UNITED STATES PATENT AND TRADEMARK OFFICE

APPLICATION NO.	FILING DATE	FIRST NAMED INVENTOR	ATTORNEY DOCKET NO.	CONFIRMATION NO.
02/319,842	08/09/1999	KLAUS-JUERGEN WESTERMANN	686	3637

Office Action Summary

DETAILED ACTION

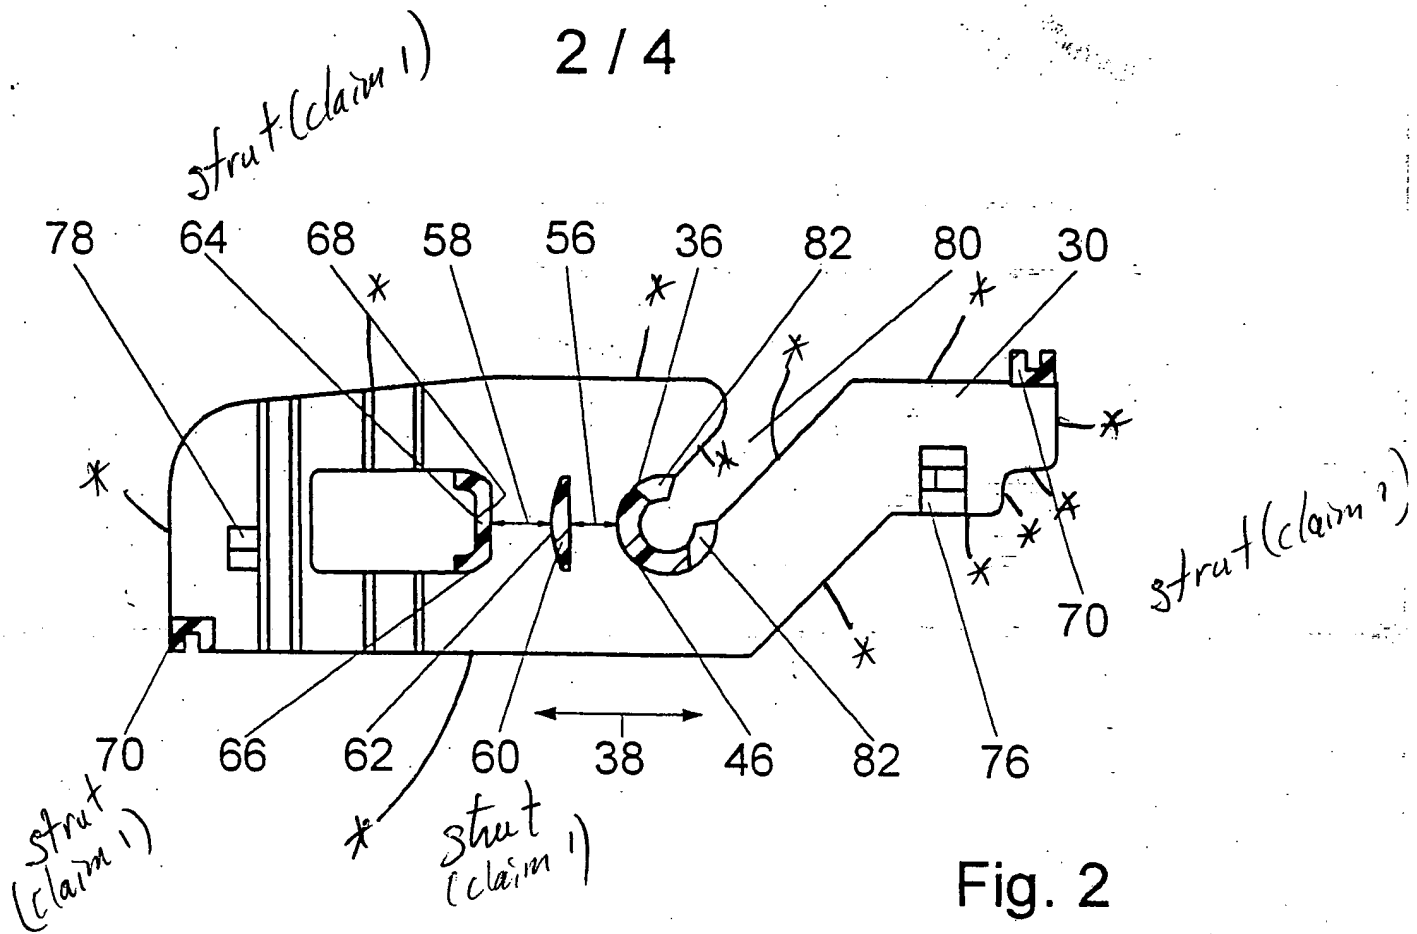
The drawings are objected to under 37 CFR 1.83(a). The drawings must show every feature of the invention specified in the claims. Therefore, the additional lateral strut disposed at ends of the side walls (claim 6) must be shown or the feature(s) canceled from the claim(s). No new matter should be entered. Applicant is reminded that applicant's drawings show two side walls each one having numerous ends (see attachment). Struts 60, 64 and 70 are covered by claim 1 and shown in Figure 6.

* Ends without
an additional strut
